# Safety Issues

- Creating New Dangerous Intersection
  - Hazardous slopes in access roads
  - High & Steep retaining walls
  - Poor Fire Equipment access
- 
- Looks good on flat paper, not so much in reality

# Entrance Road Hazards

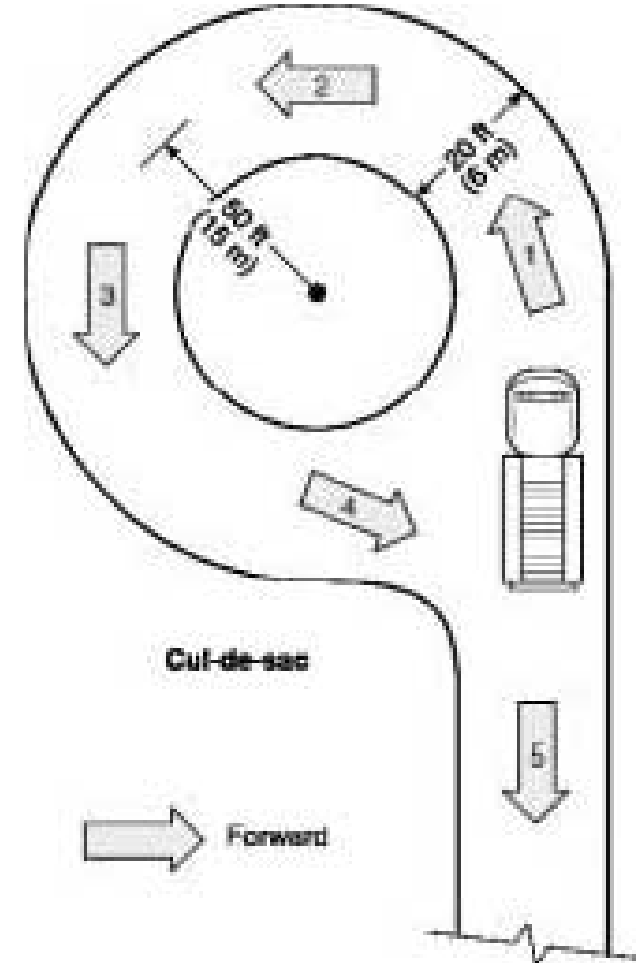
- Drop from buildings to Silvermine road is 182'  
→ 164' ~200' = 9% grade
- Steepest grade near intersection
- Really easy to overshoot
  - into --
- Blind curves on left
- Steep hill on right

# Emergency Access Road

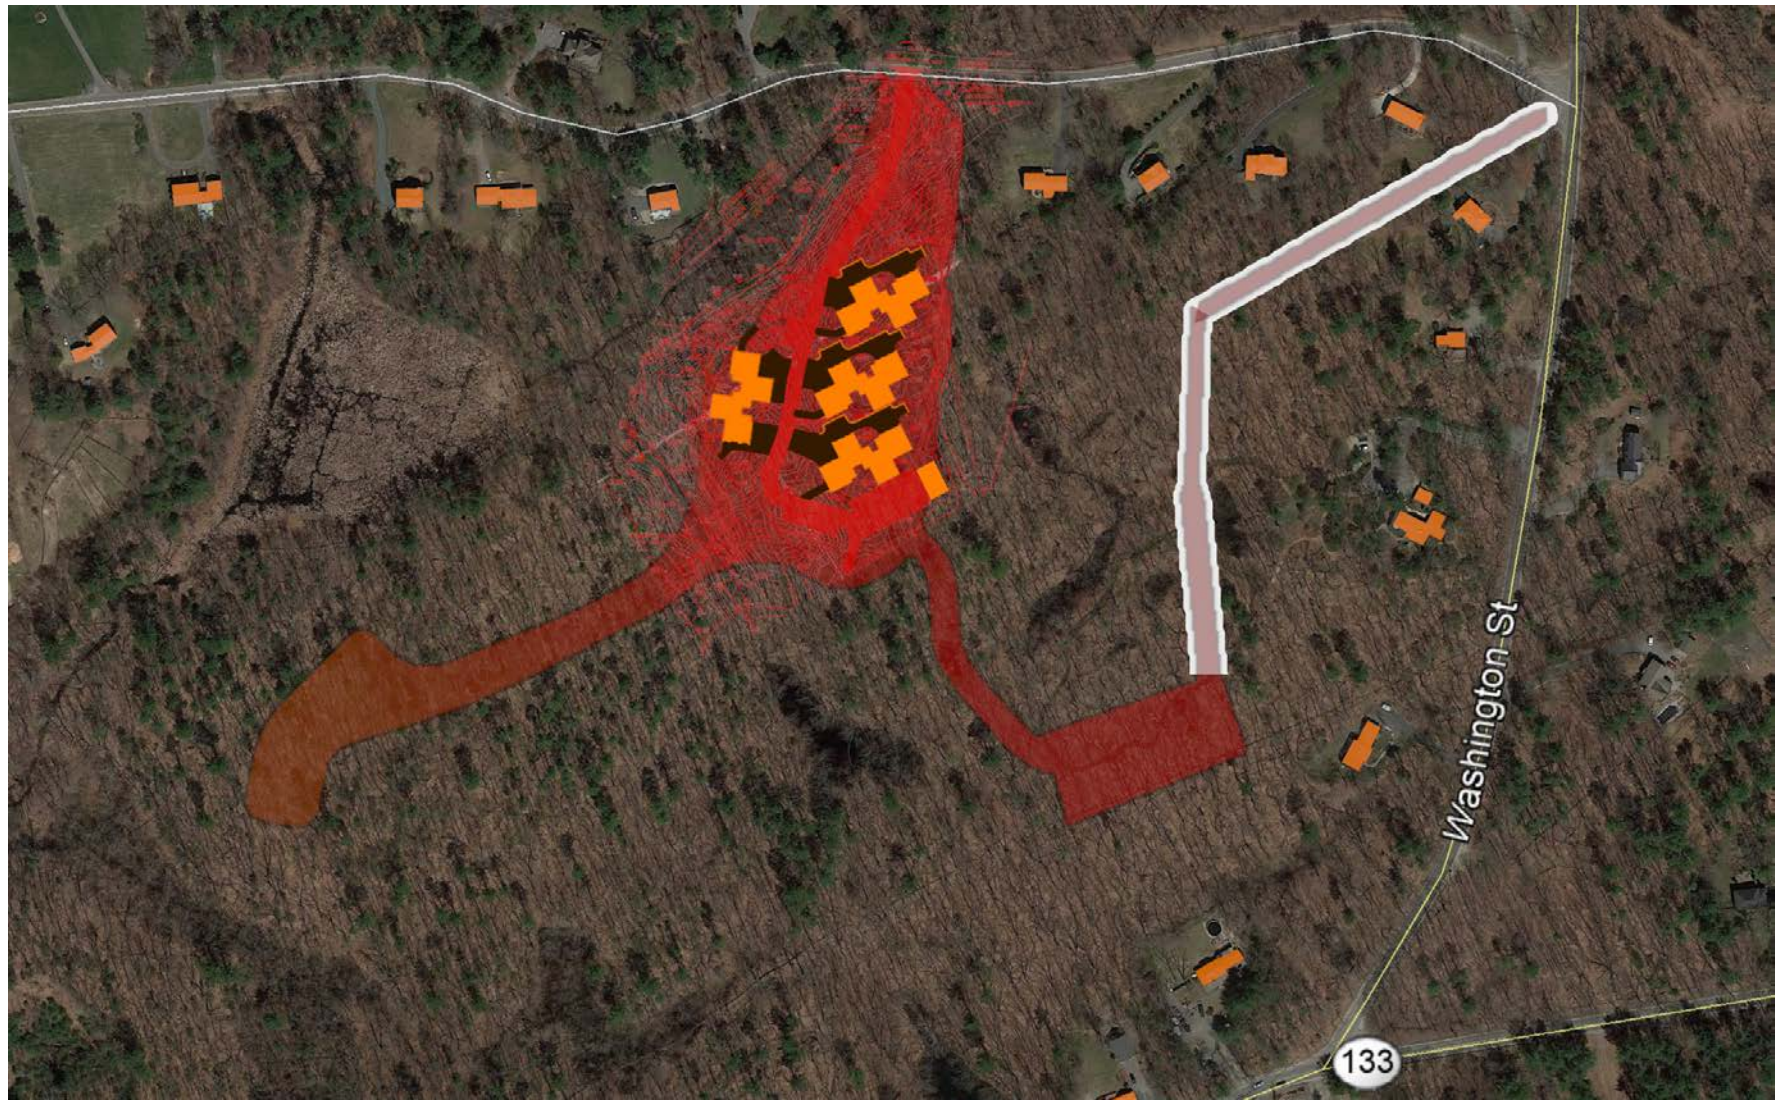
- No secondary access would be Reckless
  - NFPA 1141 requires two access routes for buildings over two stories or 30 feet in height.
  - Multiple fire lanes should be as far removed from one another as practicable.
- Plans' access path depends on “easement”

“Easement” STEEP slope w/ large gully -- How Steep?

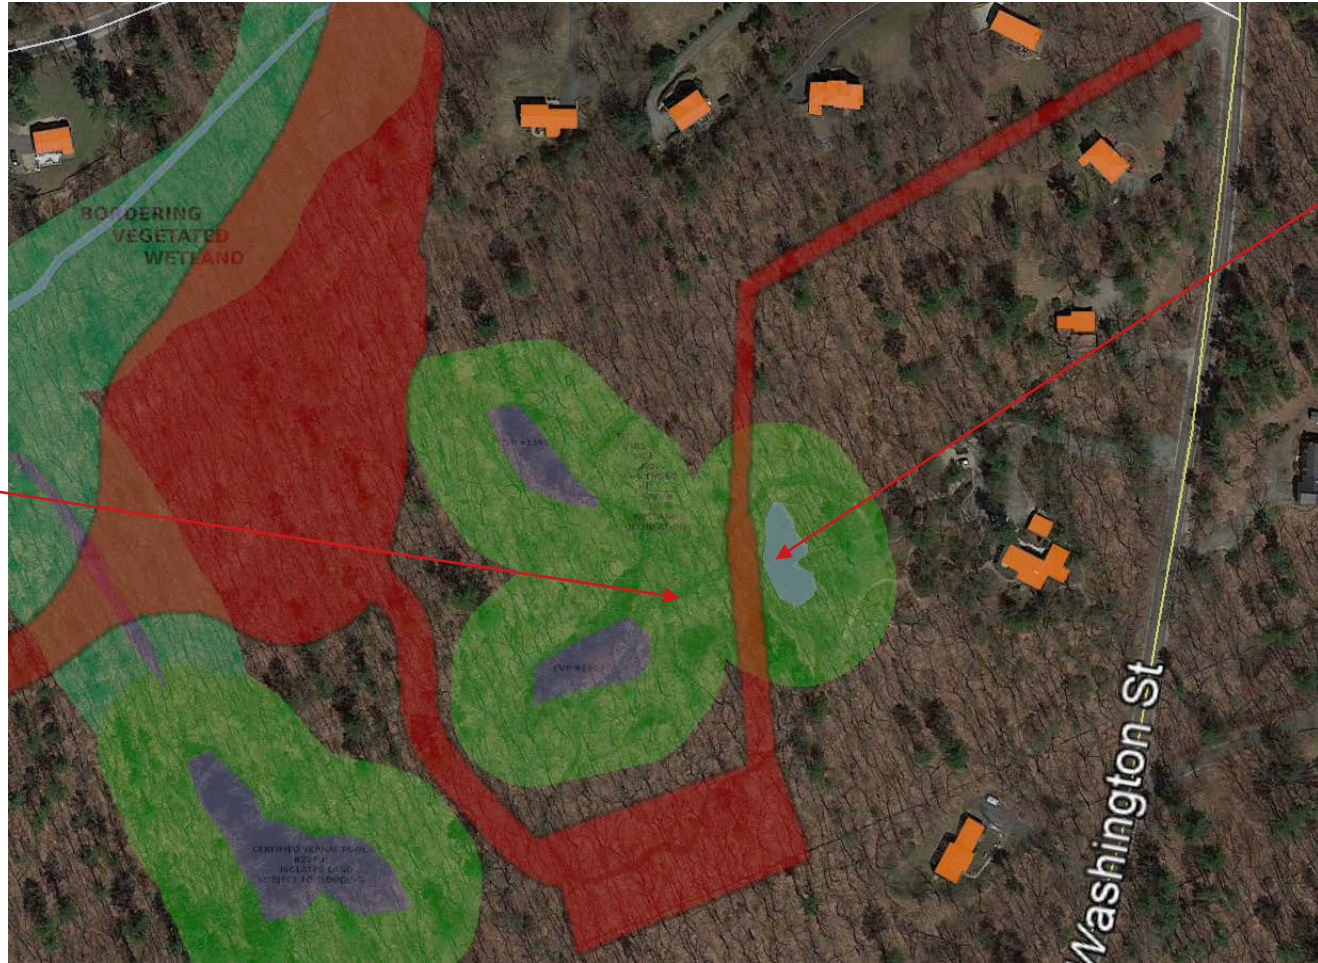
**18.9%** grade

(186' – 221' elev in 185')

Mt Washington Auto Road = **12%** grade

Fire Lane Specs = **5% to 10%** grade, less for some trucks.
